UNITED STATES PATENT AND TRADEMARK OFFICE

APPLICATION NO.	FILING DATE	FIRST NAMED INVENTOR	ATTORNEY DOCKET NO.	CONFIRMATION NO.
09/965,946	09/26/2001	Ronald E. Mizia	B-076	3356

Office Action Summary

DETAILED ACTION

Shaffer teaches a cask for radioactive material such as spent nuclear reactor fuel (see Figure 1 below).

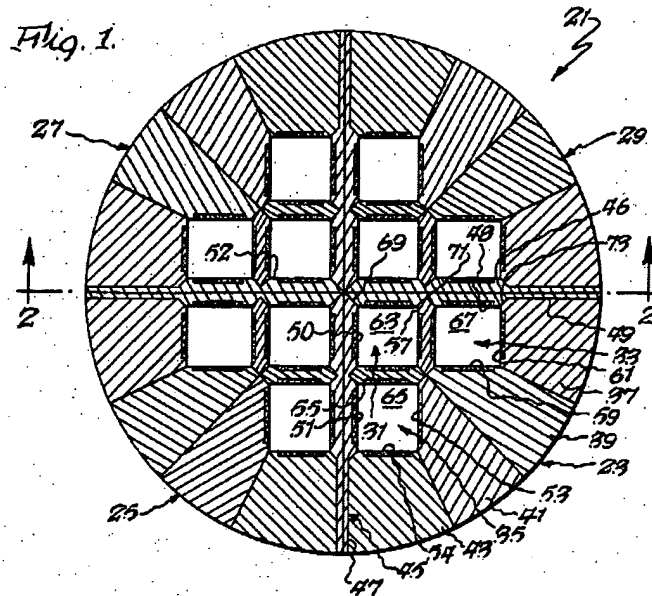
Kajimura discloses the invention substantially as claimed. However, Kajimura does not specifically teach that the steel could be used as an internal as claimed in Claim 9 or a canister as claimed in Claim 10 as defined in the present specification on page 9, paragraph 23.

The walled internal compartments 31, 33, and 35, absorb neutrons (column 1, lines 60 and 61; column 2, lines 64 and 65). Compartment walls 55 and 57 have parts that serve as bearers of neutron-absorbing material (column 2, line 67 to column 3, line 7). Regarding the parts of Claims 9 and 10, it would have been obvious to one with ordinary skill in the art at the time the invention was made that the stainless steel taught by Kajimura could be used in the cask components of Shaffer, since Shaffer teaches that the cask material could be made from stainless steel (Shaffer, column 7, lines 7-24). Also, Kajimura meets the requirement in Shaffer (column 7, lines 20 and 21) for corrosion resistance.

Shaffer teaches a cask¹ for radioactive material such as spent nuclear reactor fuel (see Figure 1 below).

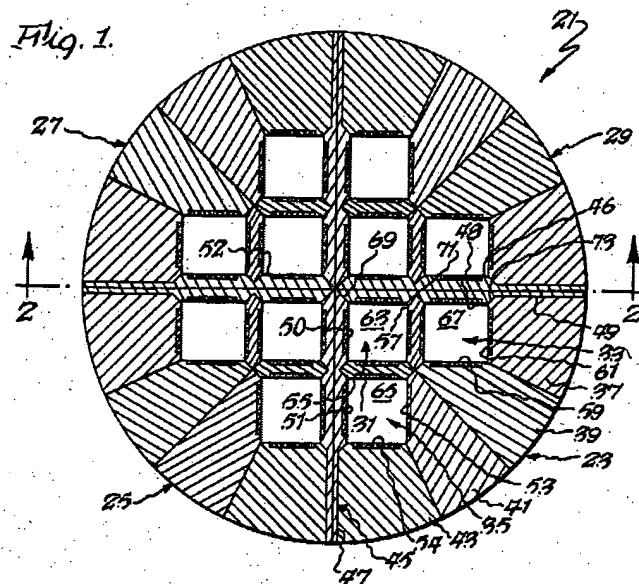
Fujiwara discloses the invention substantially as claimed. However, Fujiwara does not specifically teach that the steel could be used as an internal as claimed in Claim 9 or a canister as claimed in Claim 10 as defined in the present specification on page 9, paragraph 23.

The walled internal compartments 31, 33, and 35, absorb neutrons (column 1, lines 60 and 61; column 2, lines 64 and 65). Compartment walls 55 and 57 have parts that serve as bearers of neutron-absorbing material (column 2, line 67 to column 3, line 7). Regarding the parts of Claims 9 and 10, it would have been obvious to one with ordinary skill in the art at the time the invention was made that the stainless steel taught by Fujiwara could be used in the cask components of Shaffer, since Shaffer teaches that the cask material could be made from stainless steel (Shaffer, column 7, lines 7-24). Also, Fujiwara meets the requirement in Shaffer (column 7, lines 20 and 21) for corrosion resistance.
